Final Environmental Impact Report

San Bernardino County Overnight Solar Project

SCH No. 2024010434

2.0 COMMENT LETTERS AND RESPONSES TO COMMENTS

Figure 3.3-5. Burrowing Owl Survey Results

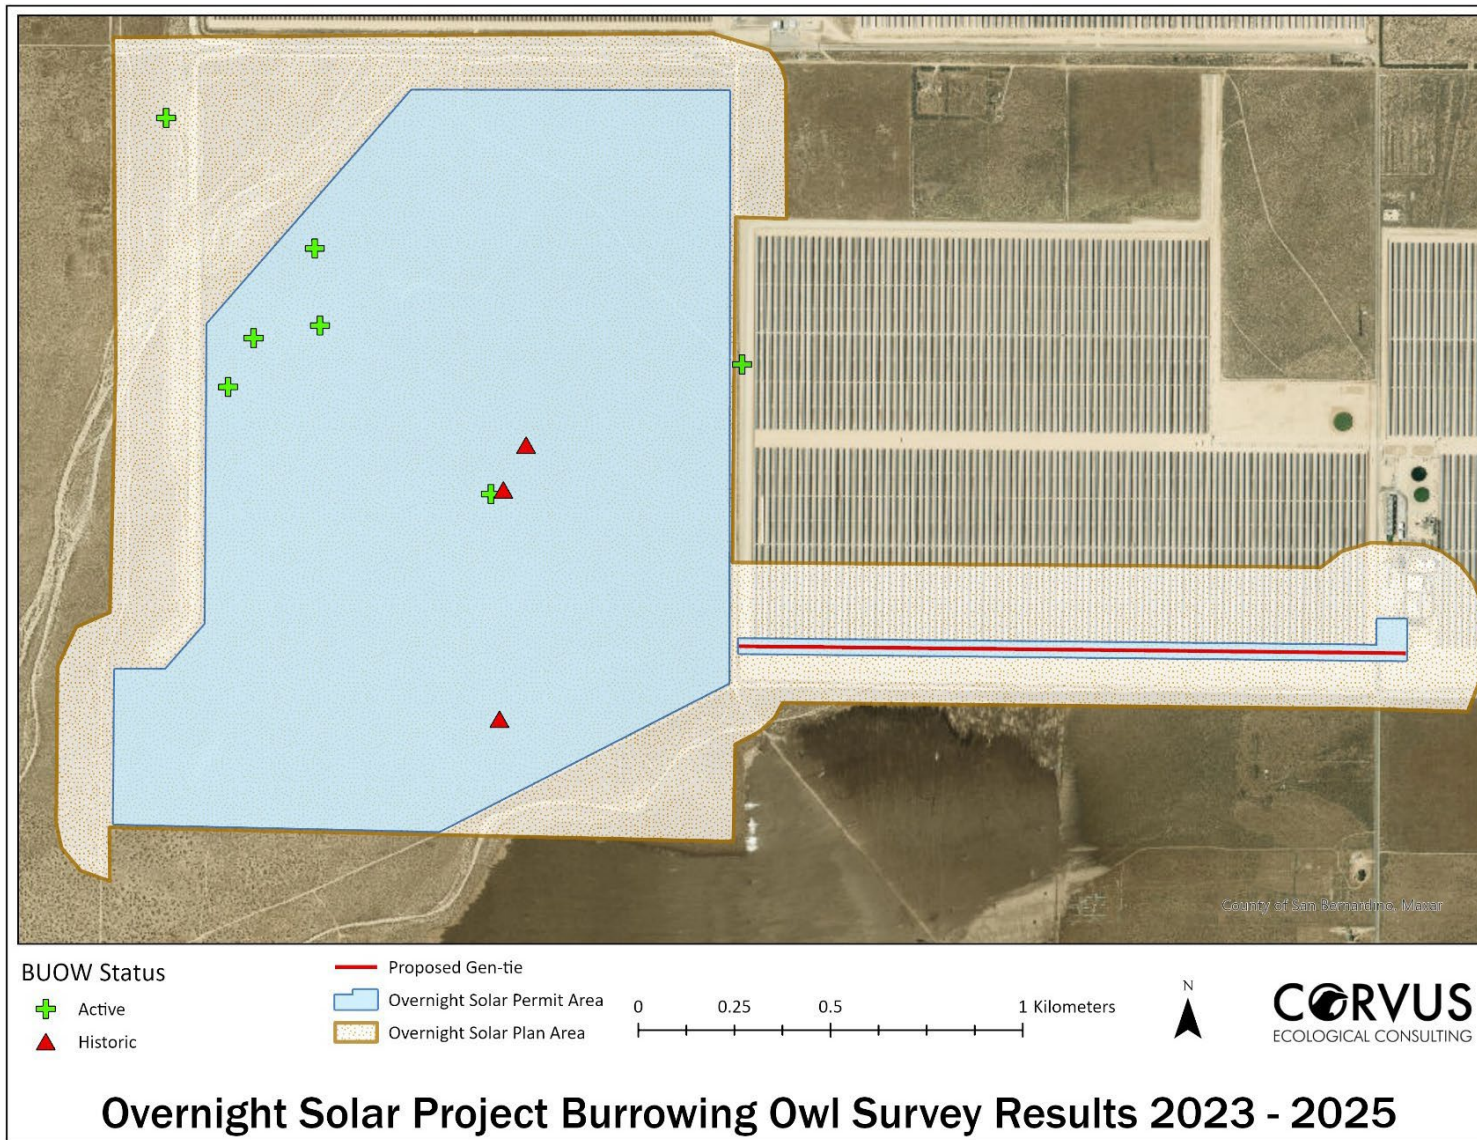
Initial burrowing owl surveys were conducted during peak breeding season in 2023 (April 15 to July 15), with two biologists walking 10-meter belt transects across the original survey area. Biologists examined natural and artificial substrates for occupation by western burrowing owl, and recorded signevidence of use (i.e., feathers, pellets, burrows, whitewash, egg fragments, live animals/breeding pairs, and live birds). Biologists marked all occupied and suitable burrowing owl burrows during this effort. During May 2023, ~~and April 2024, and March 2025,~~ all suitable western burrowing owl burrows were revisited in an effort to determine occupancy and site use. Additional western burrowing owl focused surveys were performed in May, June, and July 2024, within the current project site and a 150-meter buffer. The proposed gen-tie corridor was surveyed for burrowing owl on March 26, 2025. Signs of burrowing owl use were considered “historic” if detected within 2023 or 2024 and “active” if detected within 2025. No live Three historic signs and five active signs of burrowing owls use were have been observed within the current project footprint, one active sign of burrowing owl use has been observed northwest of the project footprint, and one active sign of burrowing owl use has been observed within the Mojave Solar Facility (Figure 3.3-5); however, evidence of their presence was recorded in the form of active soil burrows, scat, and pellets (Figure 3.3-3). The occupied burrowing owl burrow within the 150-meter buffer of the current project footprint within the existing Mojave Solar Facility, was detected more than 875 meters from the proposed project gen-tie located in the facility (Figure 3.3-5). However, no signs of burrowing owl use were observed along the proposed gen-tie corridor within Mojave Solar Facility during the 2025 surveys. For these reasons, western burrowing owl is ~~assumed~~ determined to be present within and around the project footprintsite.

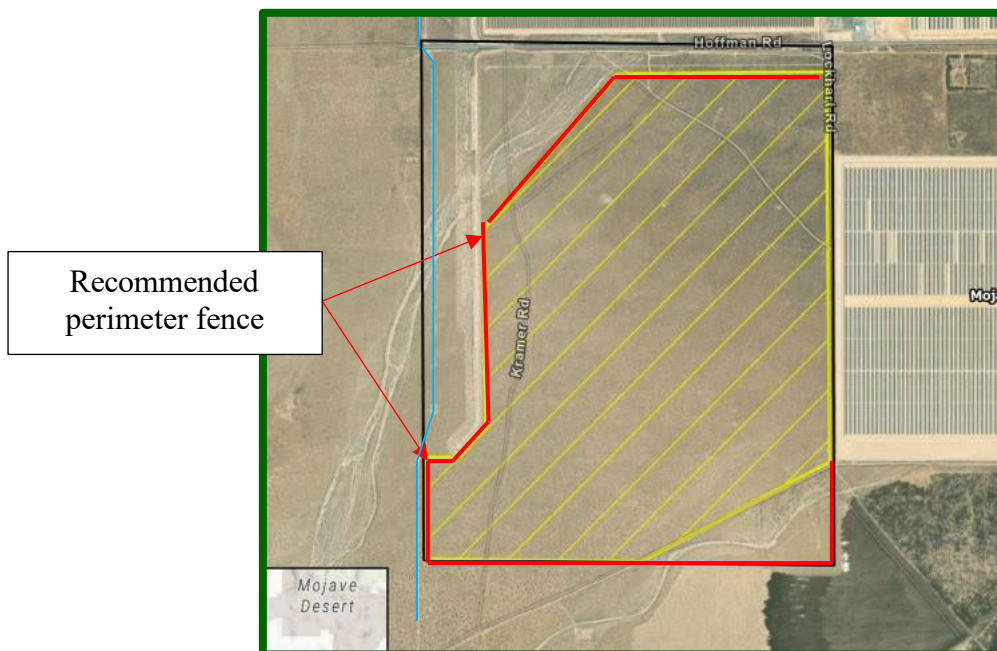
Page 1 indicates, "...panel washing would occur at least once per year and potentially up to 4 times per year. Panel washing would require up to 12 employees with water trucks and would take approximately 20 days to complete." On page 6, we also read, "Approximately 200 acre-feet of water would be used during the first year of construction." Further, "Components of the plan are likely to include water trucks to spread water, as well as road stabilization with chemicals, gravel, or asphaltic pavement to mitigate visible fugitive dust from vehicular travel and wind erosion."

Please be sure the Draft EIR addresses current aquifer characteristics and how this project, combined with the other existing and proposed solar projects, including the Desert Breeze solar project, may affect the aquifer. Our relatively more pertinent concern with the use of so much water is the attraction of known predators, including common ravens and coyotes, into the project area, potentially increasing depredation of tortoises in adjacent areas. Panel washing and dust suppression if not applied in a conscientious manner will result in water puddling onsite and runoff into adjacent areas, which are both human-subsidized water sources for these predators.
